# COLORADO DEPARTMENT OF HIGHWAYS

*W 54th  
to W 26th to E 1st*

RIGHT OF WAY

## PLAN AND PROFILE OF PROPOSED FEDERAL AID PROJECT NO. C II-0058-II STATE HIGHWAY NO. 58 JEFFERSON COUNTY

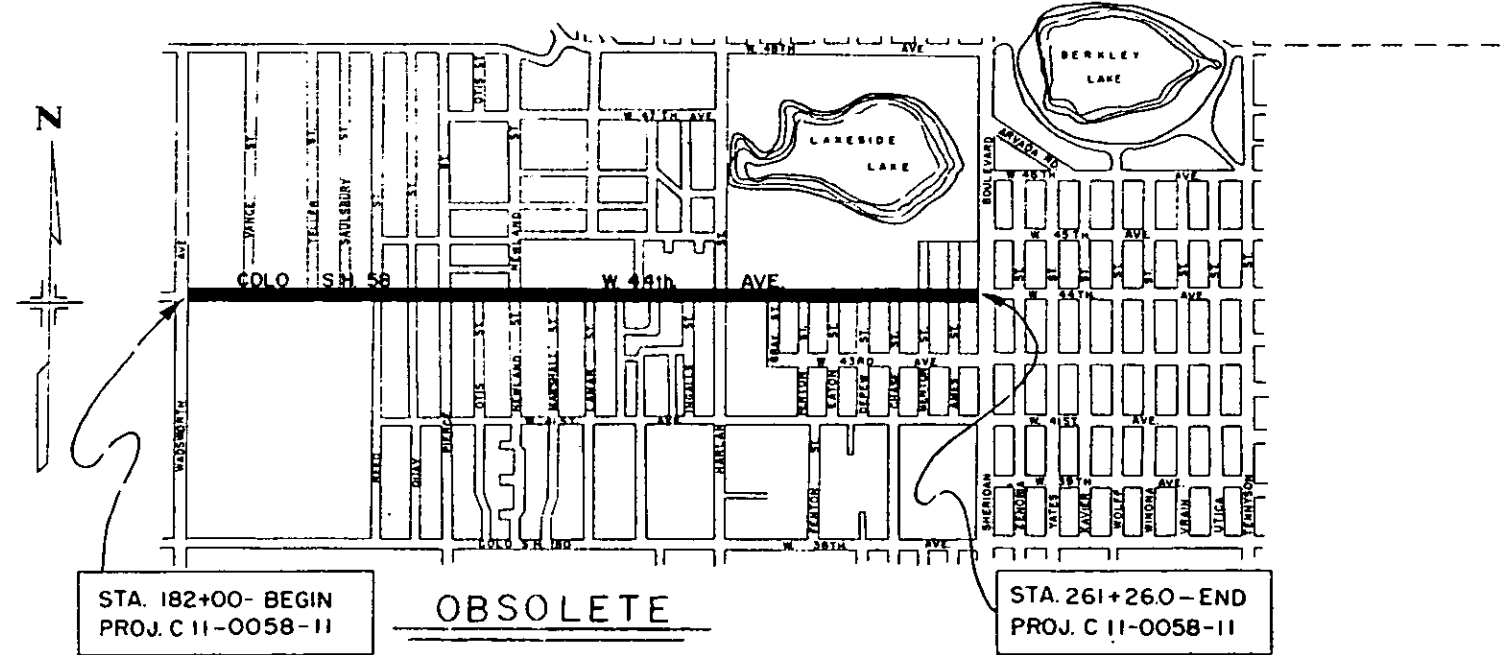
*This will be  
 changed to  
 1/4 section line  
 1/2 section line  
 3/4 section line*

FED. ROAD DIV. NO.	DIST.	PROJ. NO.	SHEET NO.	TOTAL SHEETS
9	COLO.	C11-0058-11	3	5

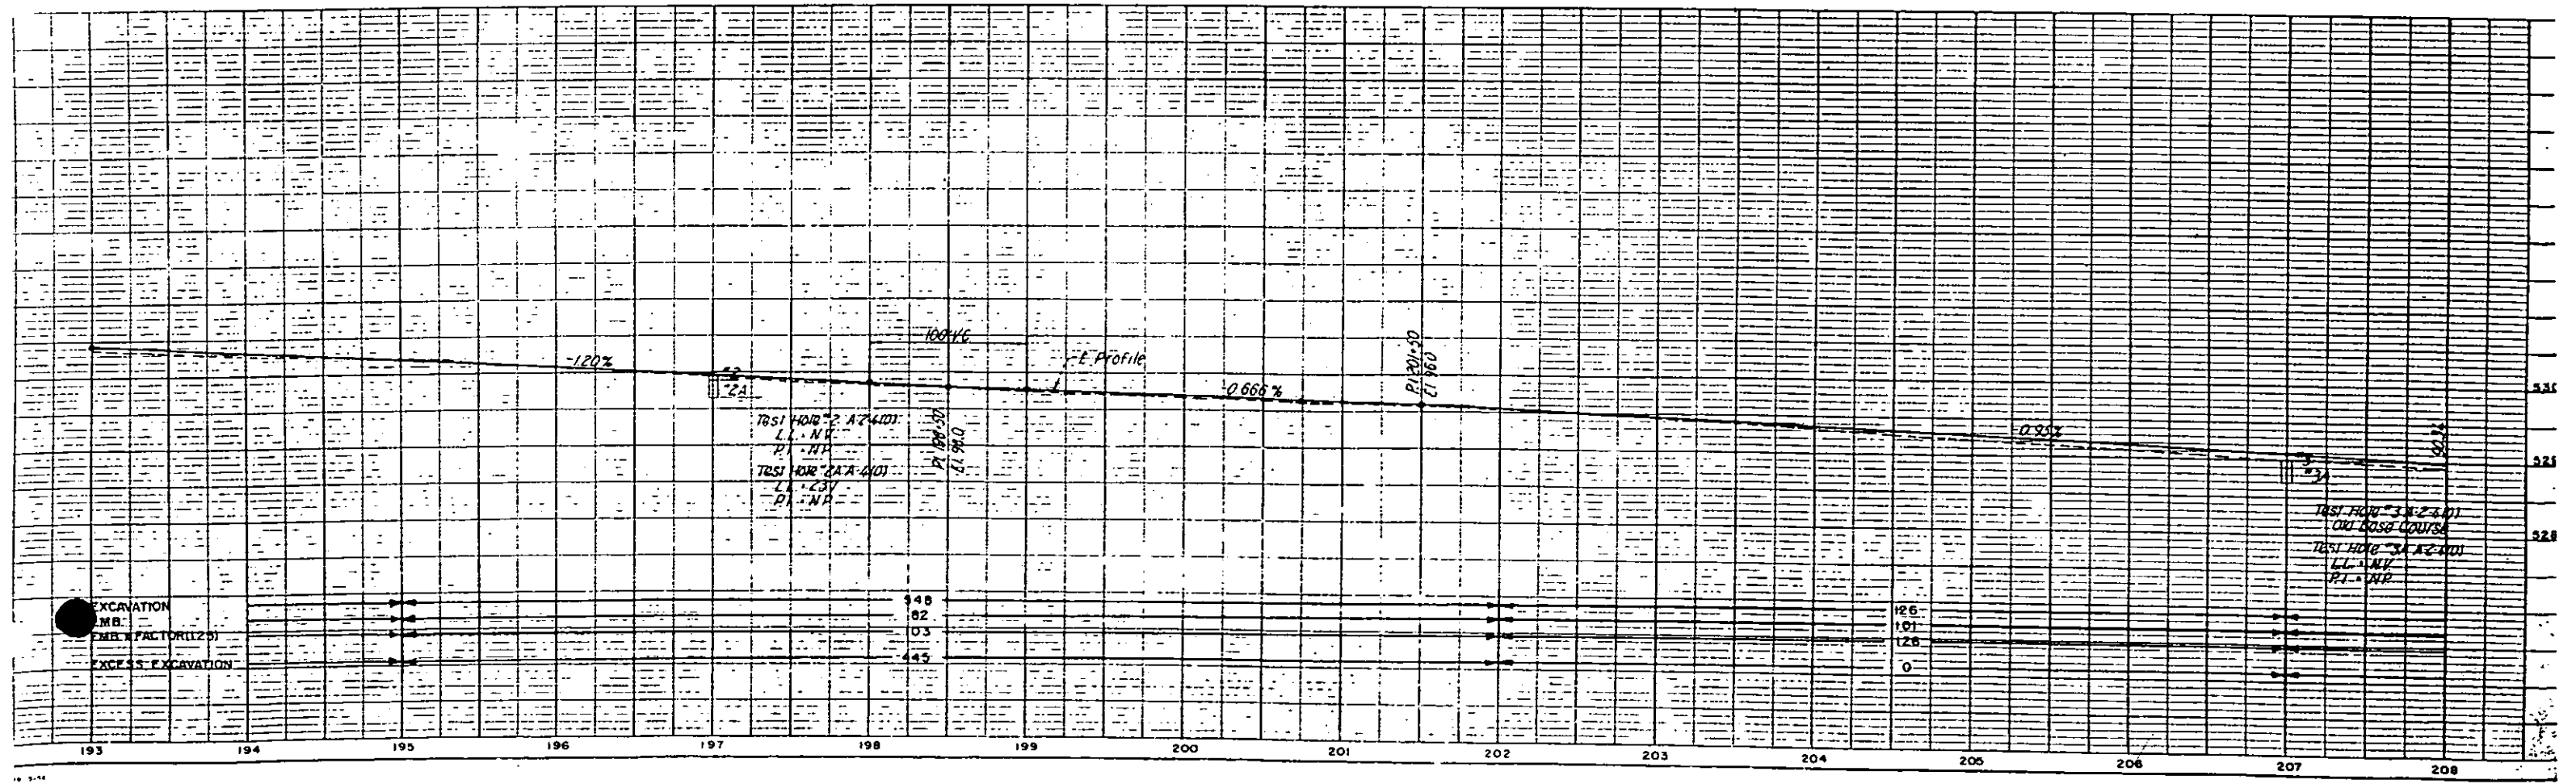
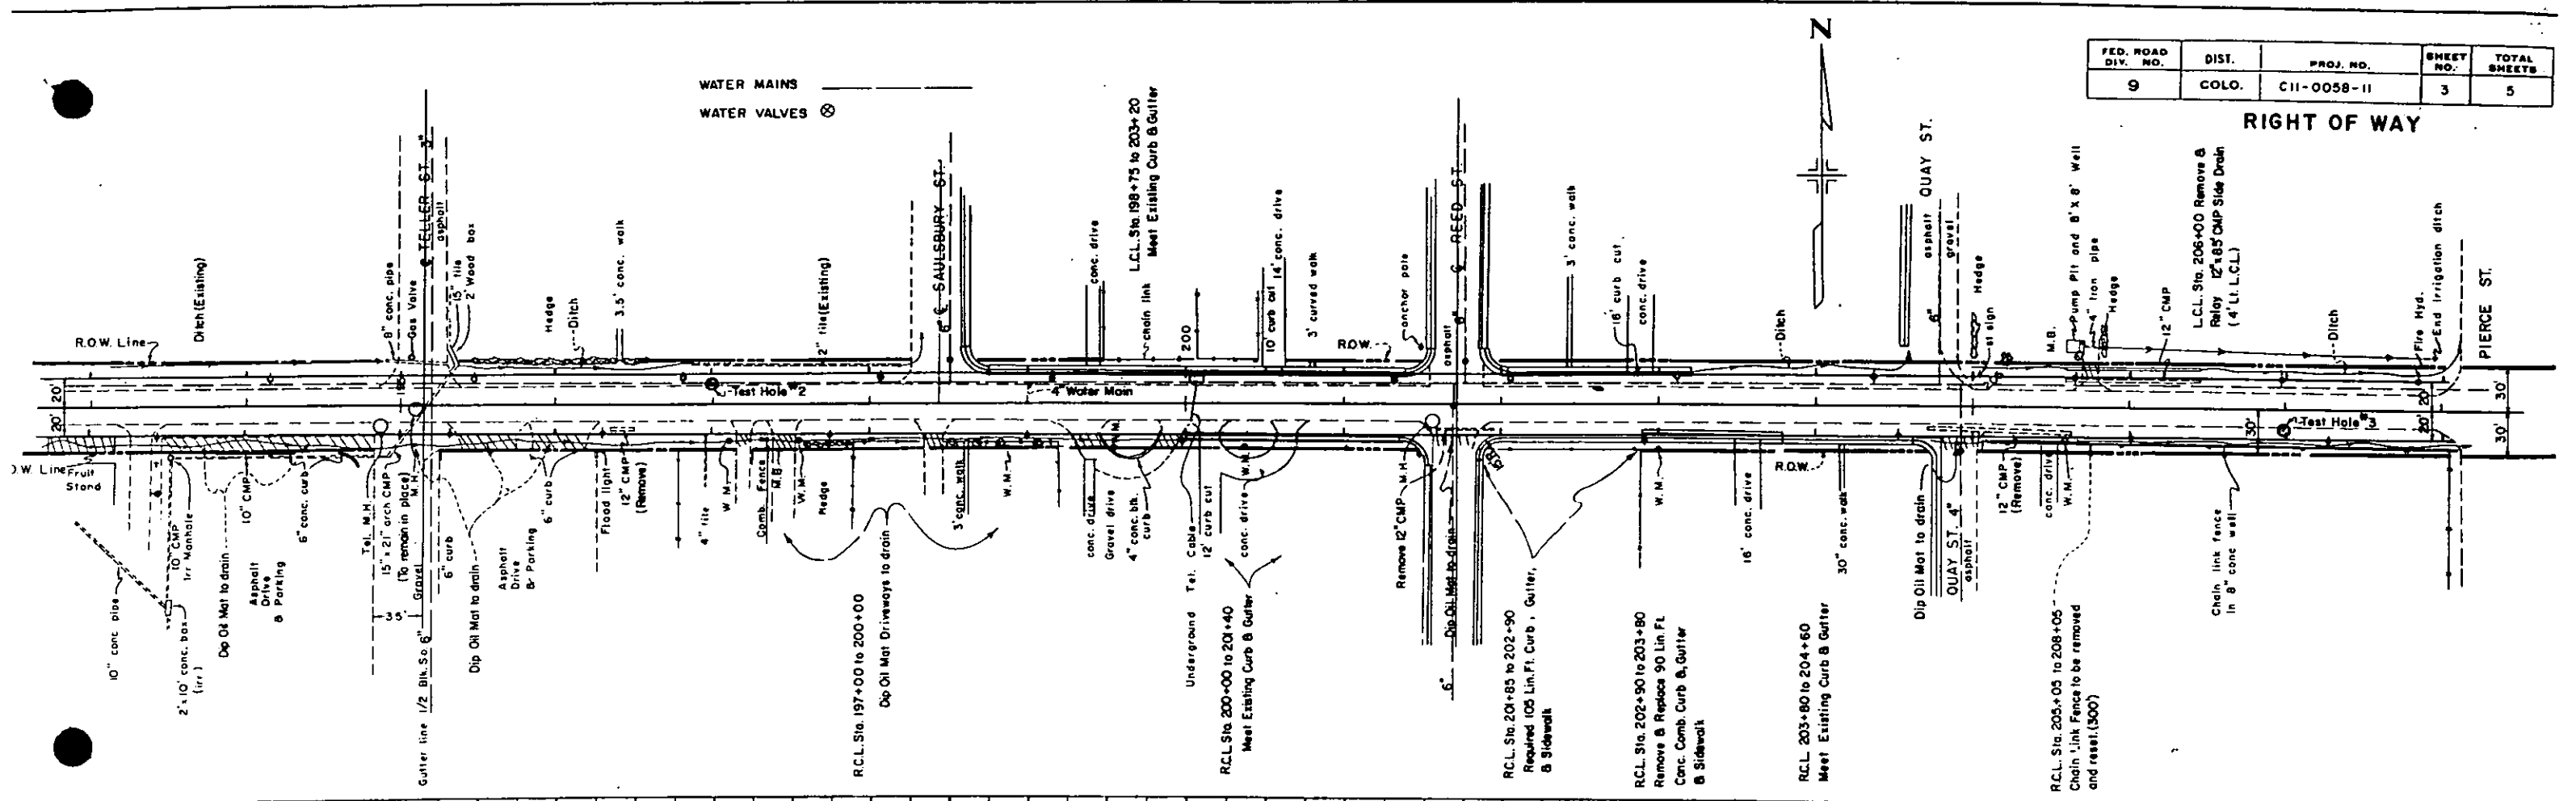
NOTE: Along Shopping Center Frontage an additional 10' lane is required for mixing lane. New curb shall be extended to intersect curb in place at all Driveway Entrances, and Oil Mat warped to form an easy riding entrance or exit.

FED. ROAD DIV. NO.	DIST.	PROJ. NO.	SHEET NO.	TOTAL SHEETS
9	COLD.	C 11-0058-11	5	5

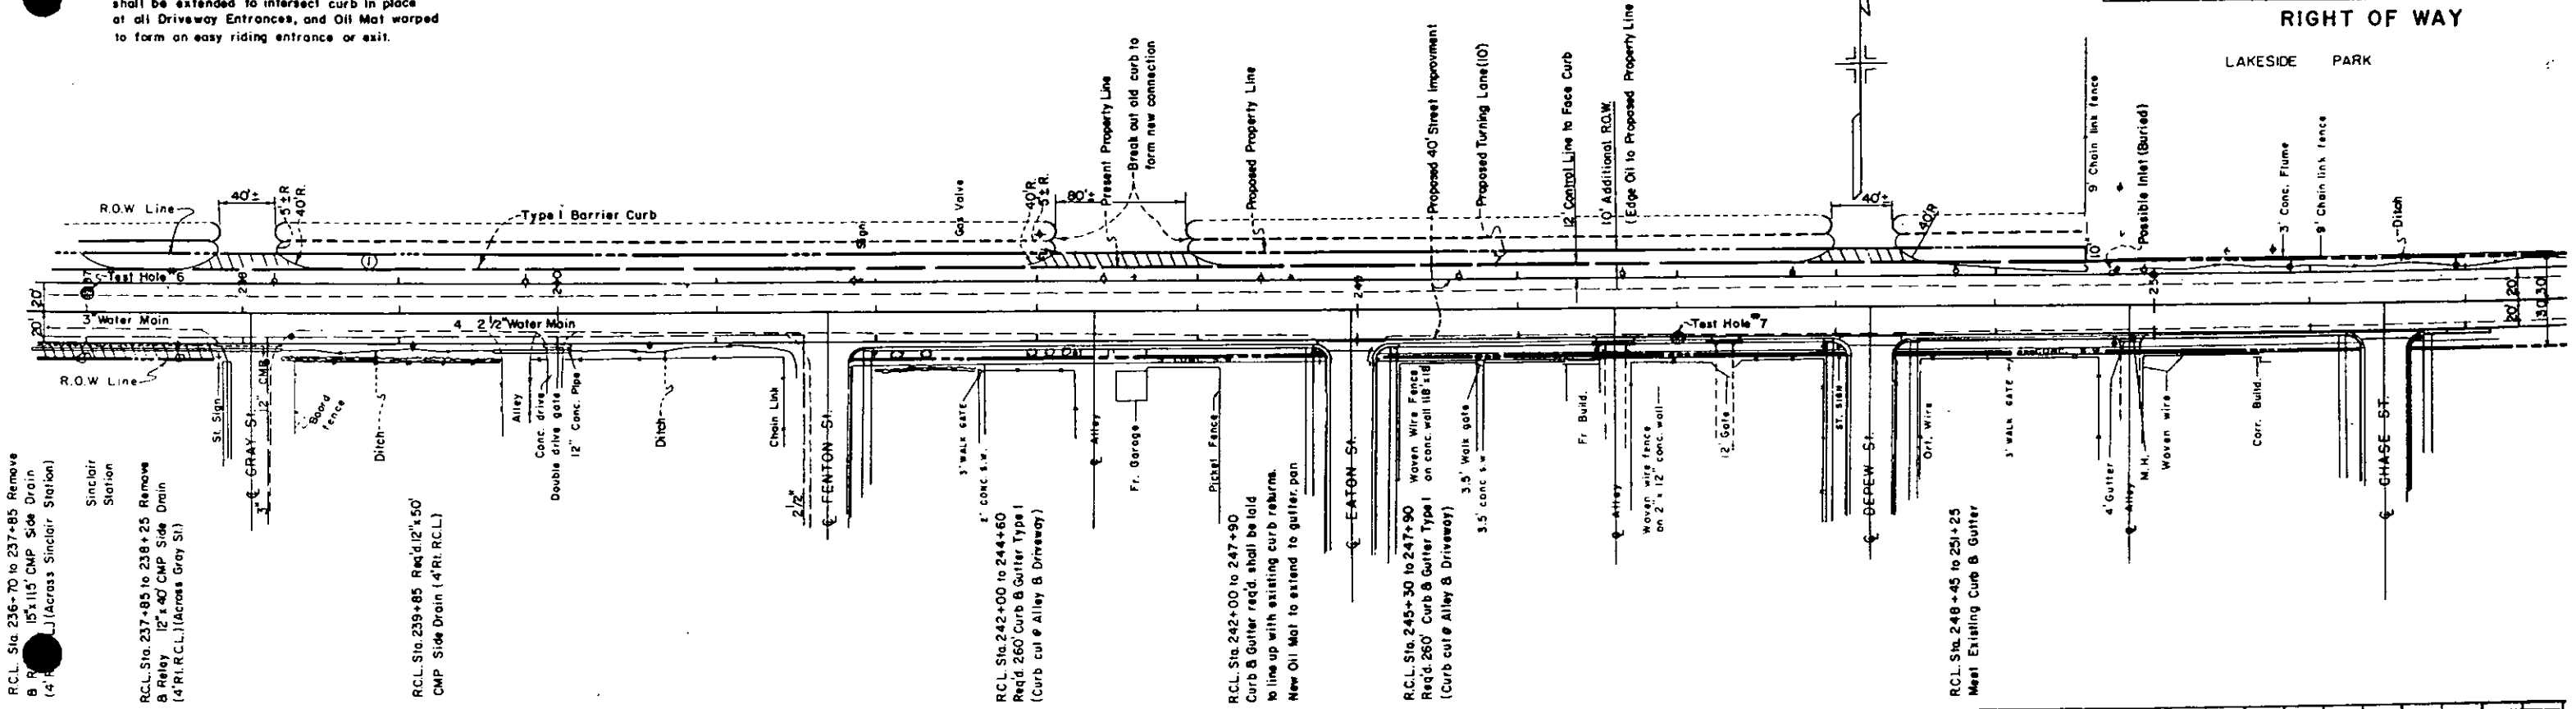
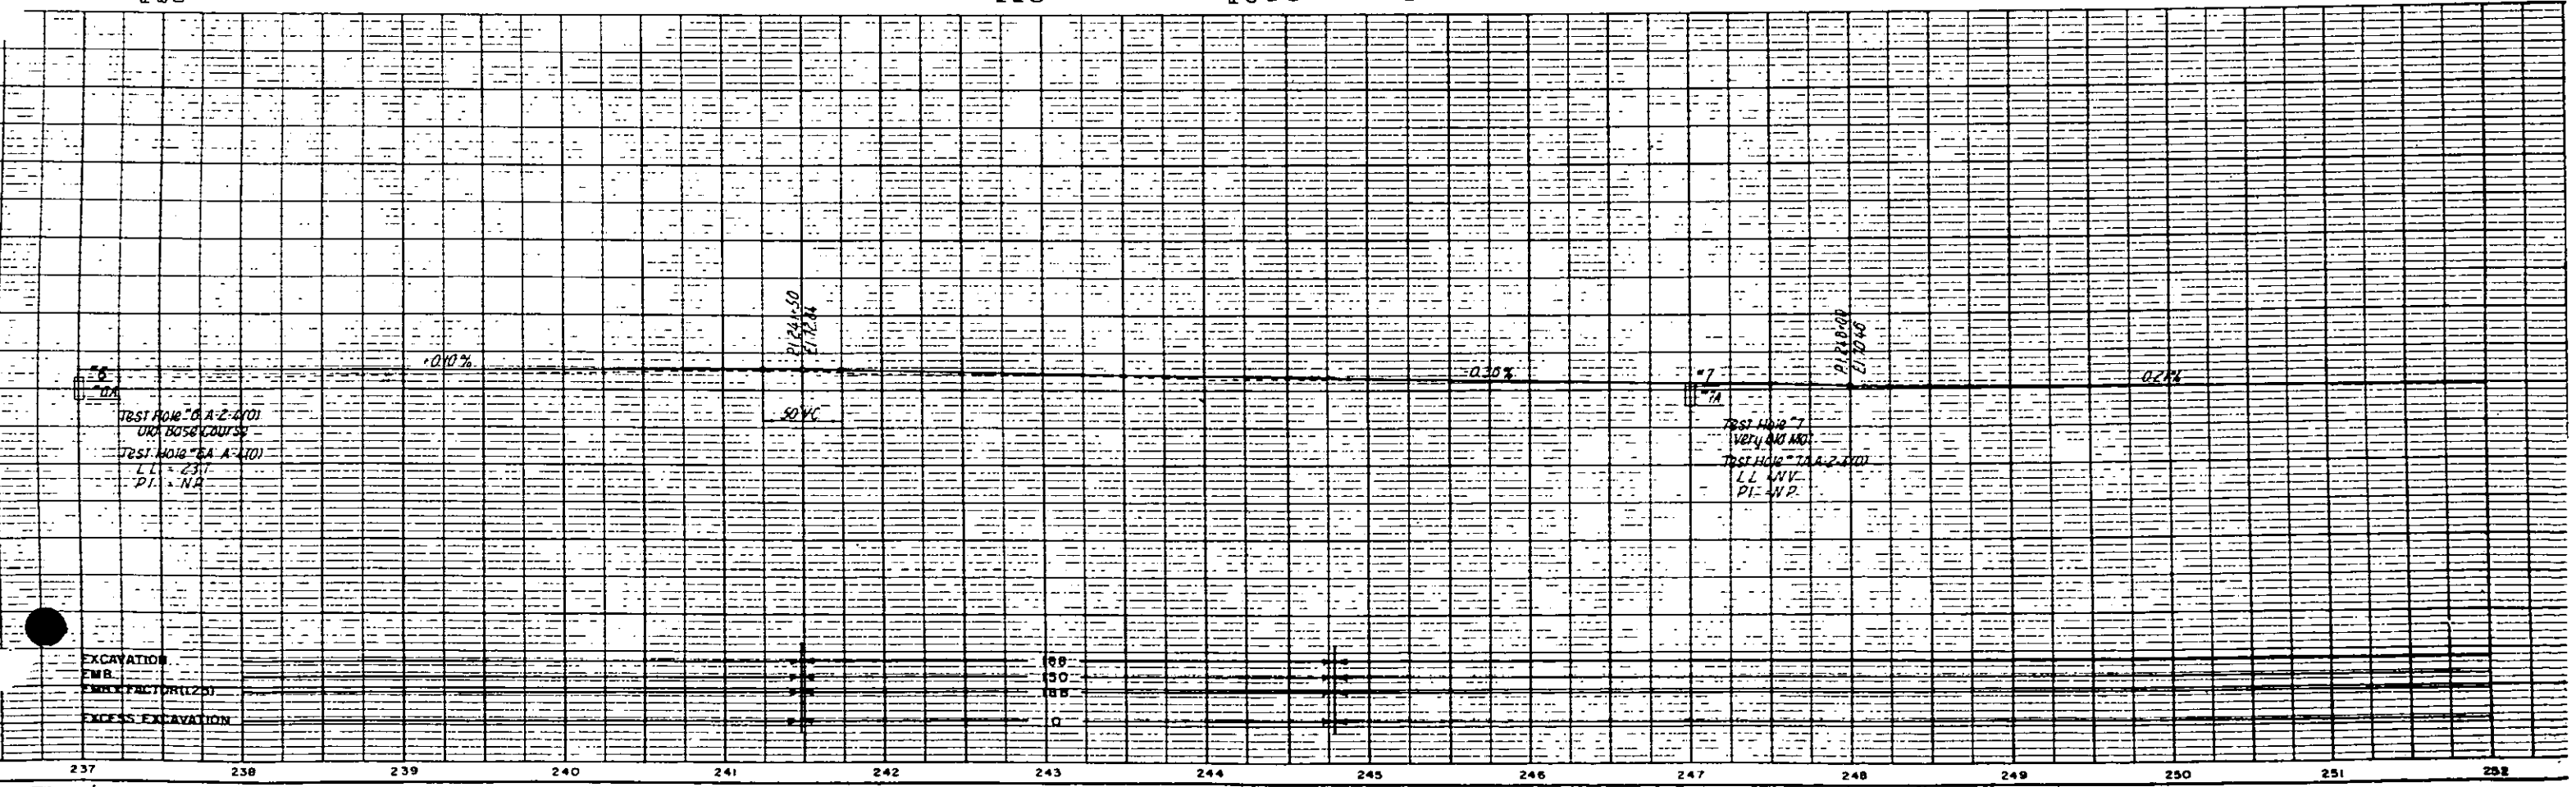
R.C.L. Sta. 236+70 to 237+85 Remove  
B R 15' x 15' CMP Side Drain  
(4' R.C.L.) (Across Sinclair Station)

R.C.L. Sta. 237+85 to 238+25 Remove  
B Relay 12' x 40' CMP Side Drain  
(4' R.C.L.) (Across Gray St.)

R.C.L. Sta. 239+85 Req'd 12' x 50'  
CMP Side Drain (4' R.C.L.)

R.C.L. Sta. 242+00 to 244+60  
Req'd 260' Curb & Gutter Type I  
(Curb cut @ Alley & Driveway)

R.C.L. Sta. 242+00 to 247+90  
Curb & Gutter req'd. shall be laid  
in line up with existing curb returns.  
New Oil Mat to extend to gutter pan

R.C.L. Sta. 245+30 to 247+90  
Req'd 260' Curb & Gutter Type I on conc. wall 18" x 18"  
(Curb cut @ Alley & Driveway)

R.C.L. Sta. 248+45 to 251+25  
Meet Existing Curb & Gutter
